**DESIGN REVIEW
REC PROPOSAL
300 W Republican Street
Seattle, WA 98119**

NEW MULTIFAMILY BUILDING | KOZ DEVELOPMENT

**SDCI # 3036974-EG
West Design Review Board
Meeting Packet for 2/16/22**

Response to EDG/DRB 1 Comments

1 North Courtyard Partial Plan - Removed Circulation
1/8" = 1'-0"

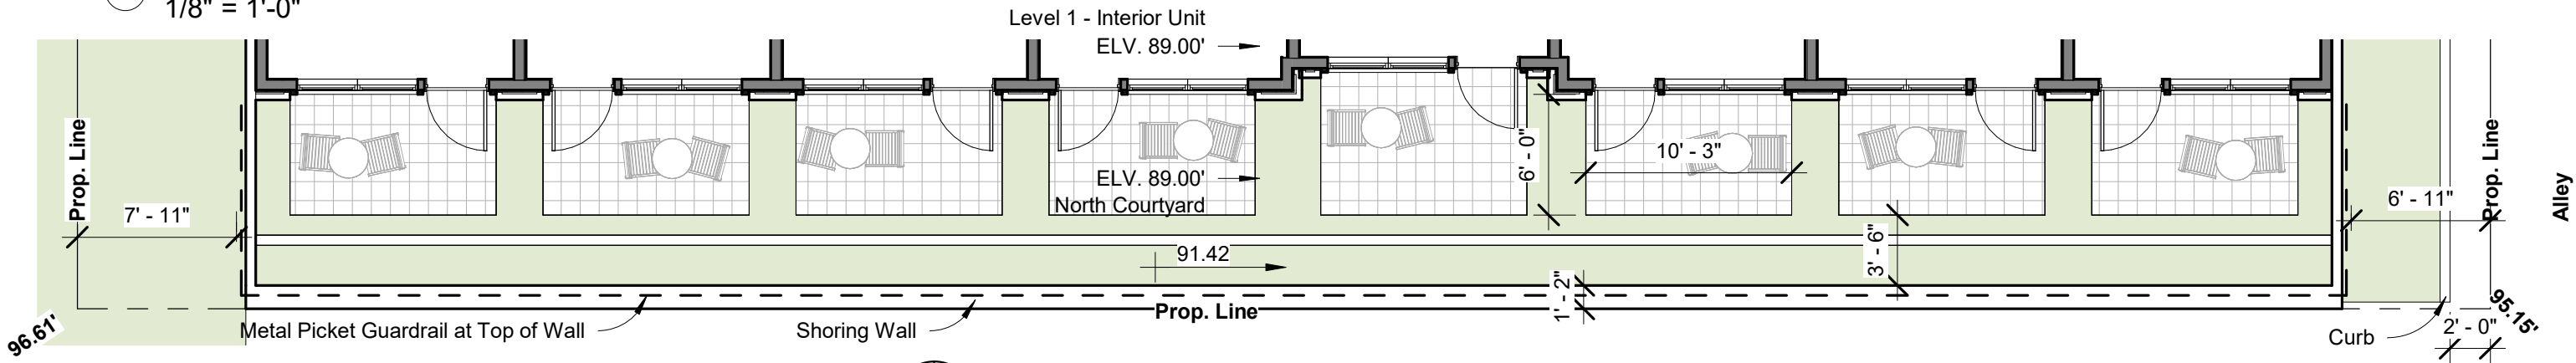
c.) The Board directed further study of the entry experience and design of the private patios along the north property line in response to Uptown Design Guideline PL3-3, Ground Level Residential Edges, and requested more detail on the design of these individual ground-level units in the Recommendation packet. (PL3-A, PL3-B, PL3-3)

The north building façade abuts an adjacent parcel, which will likely be developed in the future. To achieve large windows for the north facing units the façade was set back from the property line a minimum of 10' to take advantage of the 45% allowable unprotected openings and to provide "breathing" room from the adjacent parcel. This setback allows the units at level 1 to take advantage of the ground area for private courtyard space and will have direct access to the exterior from the units. Due to height constraints and interior program the level 1 units and courtyards are proposed to be set below grade at the level 1 elevation of 89.0. The current design intent of the shoring wall will be to use textured concrete and climbing vines to soften the look and feel.

1 Arch Landscape Plan
1/16" = 1'-0"

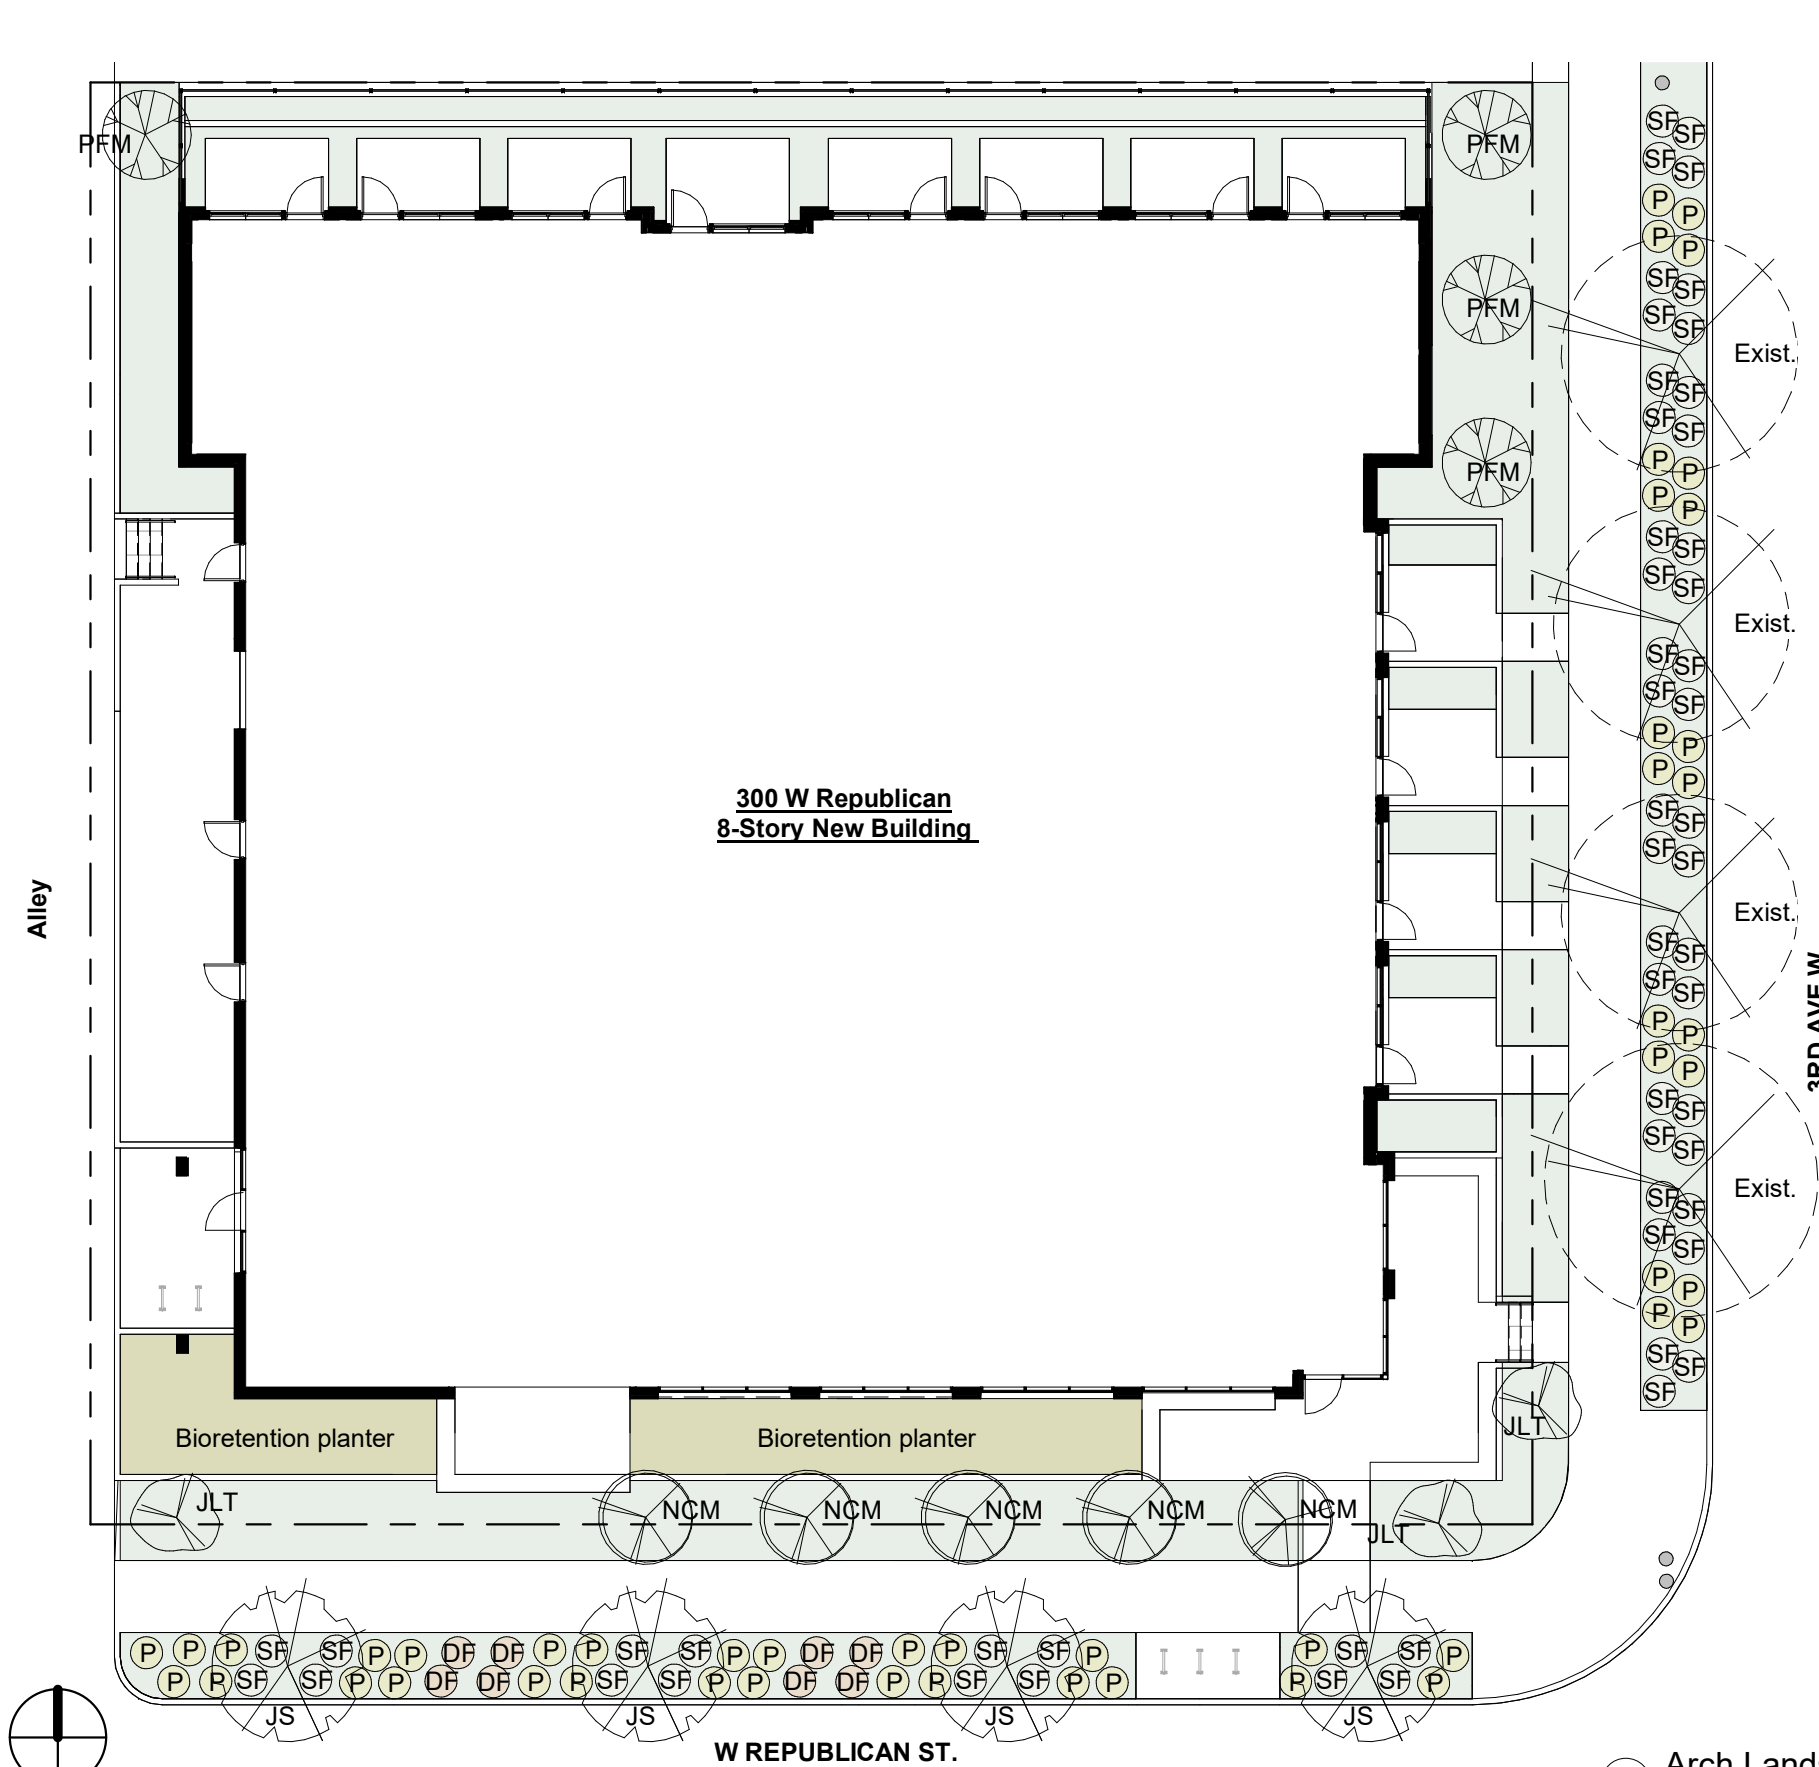
c.) The Board specifically prioritized Uptown Design Guideline DC4-4, Trees, Landscape and Hardscape Materials, and requested a landscape plan in the Recommendation packet that identifies plantings and hardscape materials. (DC4-D, DC4-4)

A detailed landscape plan that identifies plant species has been provided.

1 Site Lighting Plan - Current Proposal
1/16" = 1'-0"

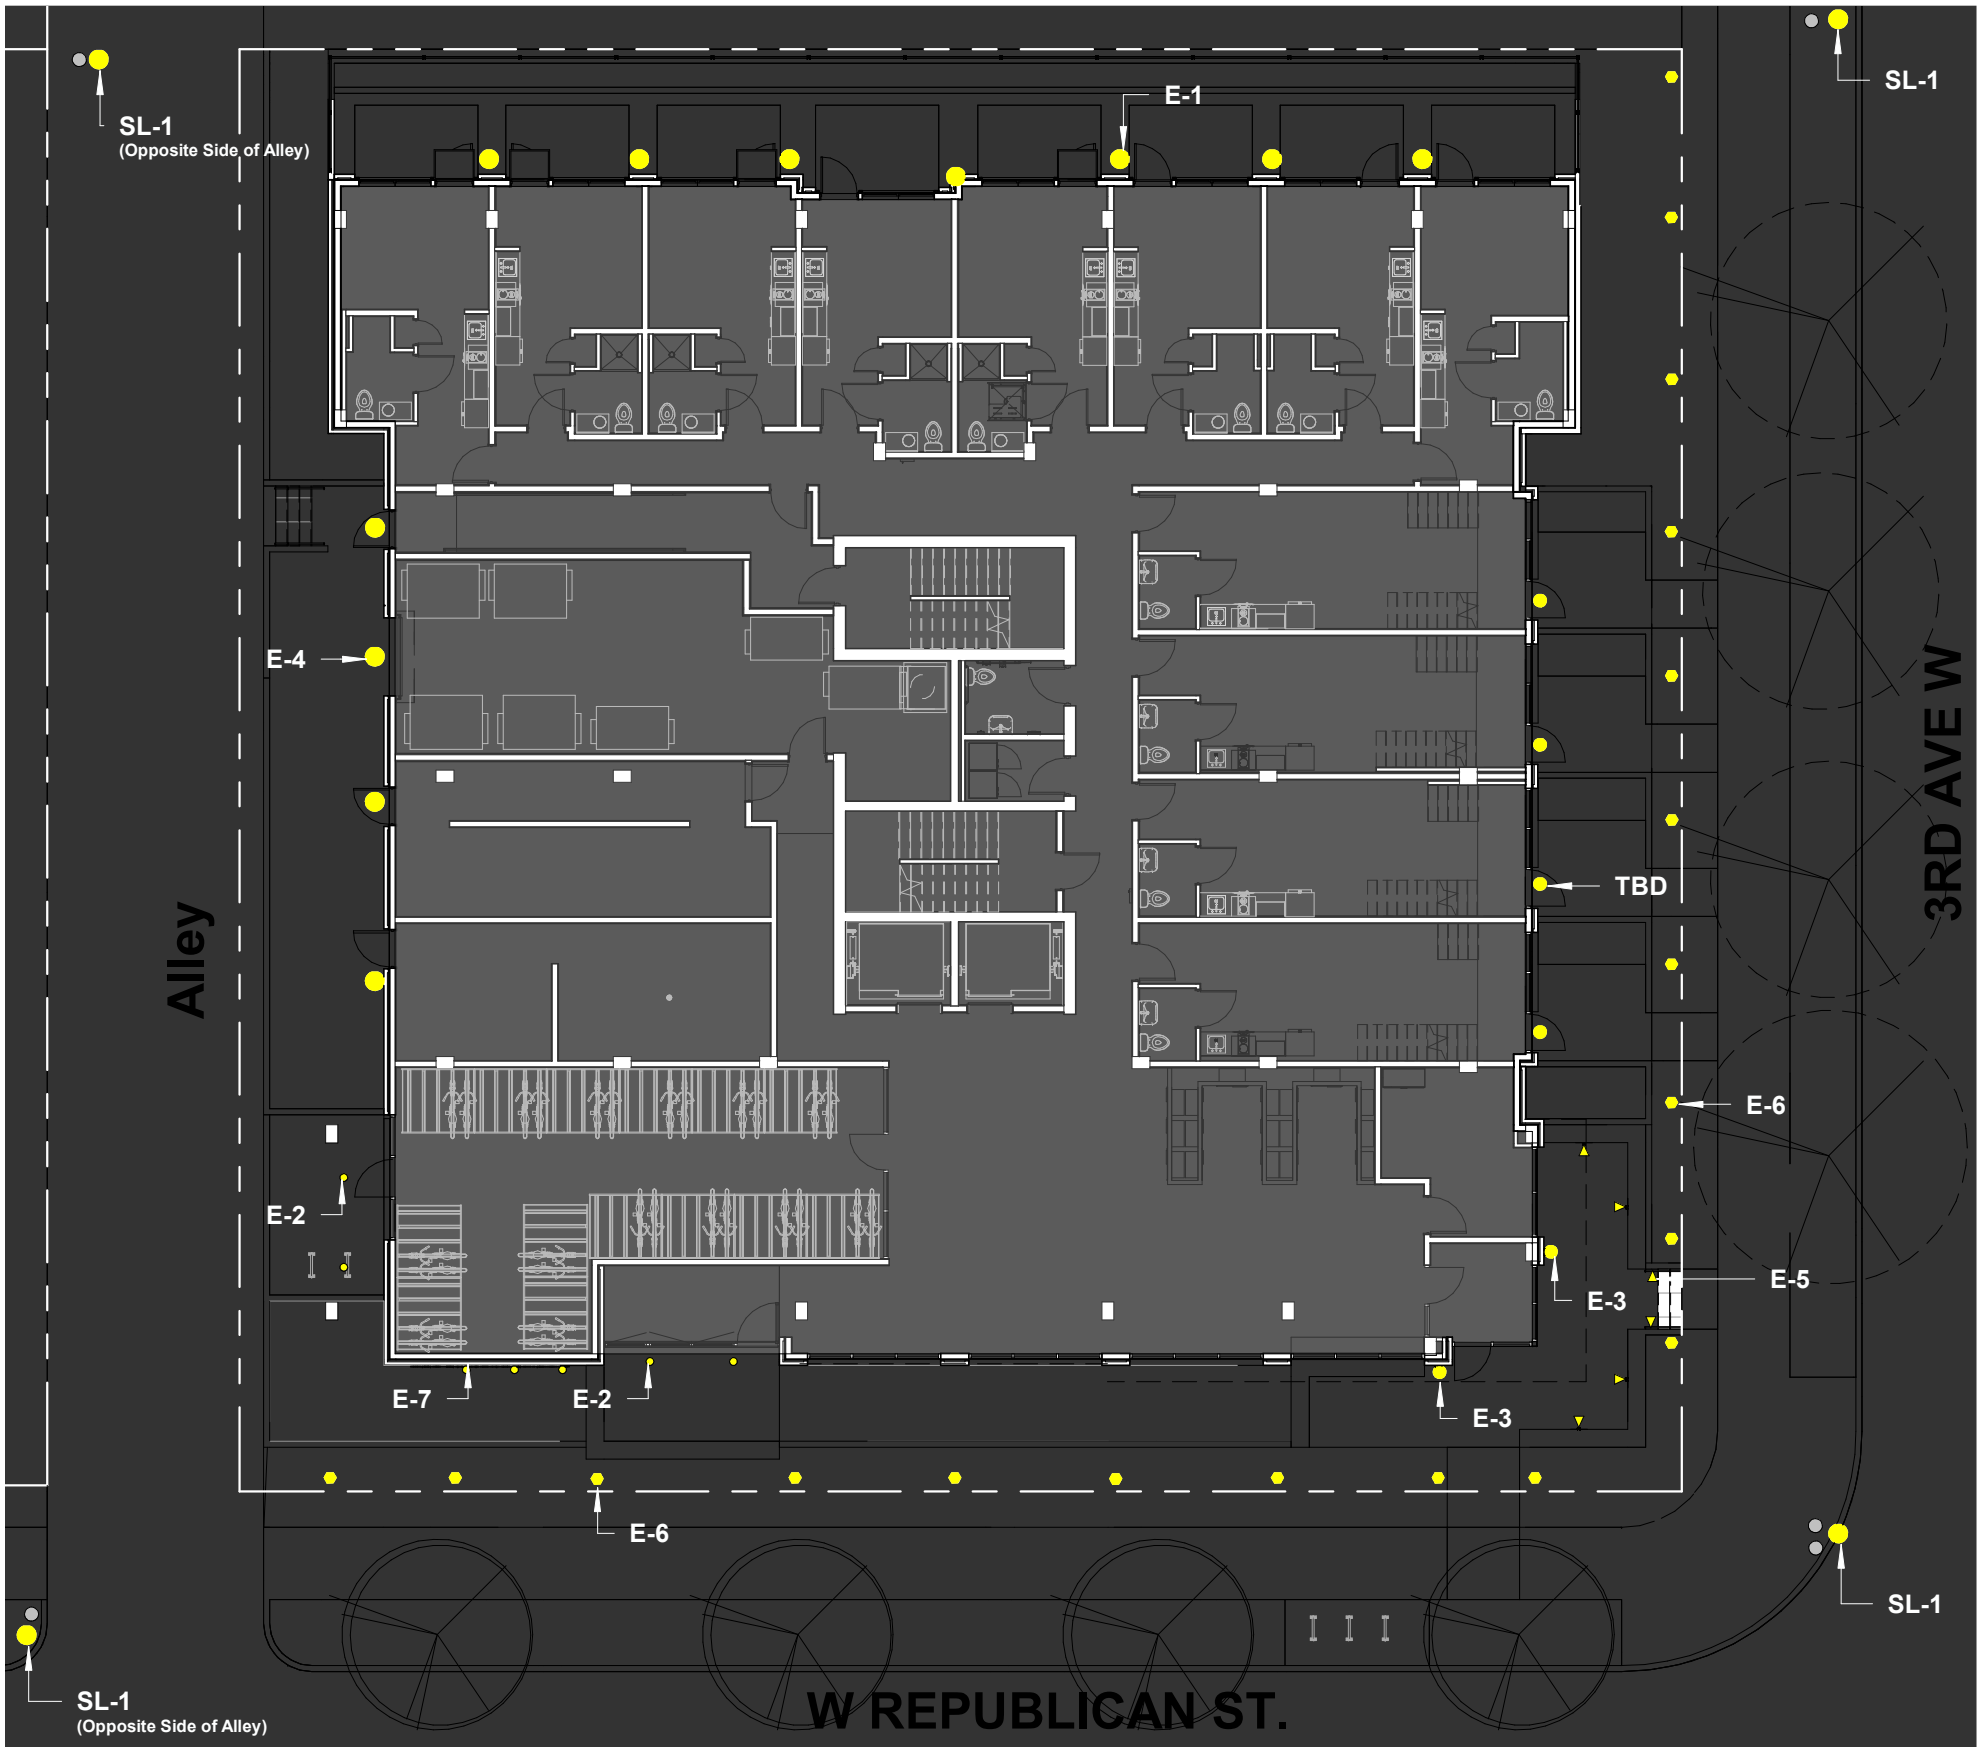
d.) The Board specifically prioritized Design Guidelines DC4-B, Signage, and DC4-C, Lighting, and stated the lighting plan should avoid “up lighting”. (DC4-B, DC4-C)

Attention has been given to the pedestrian level lighting adjacent to the sidewalks within the landscaping, building mounted lighting, and illumination for the building signage. The previously proposed landscape uplighting has been deleted. For additional details on lighting design, type, and locations refer to the lighting site plan and lighting elevations within this packet. For signage location, lighting, and details refer to the signage concept plan within this packet.

A rhythm of up/down wall mounted building lighting is proposed along the base of the building. At the lower level residential units the fixture type would change type to help create an individual expression and residential feel. The concrete landscape # 2 planters along 3rd Ave and Republican Street shall have appropriate pedestrian-scaled lighting within the planters. All lighting is intended to provide both security and visual interest to the building.
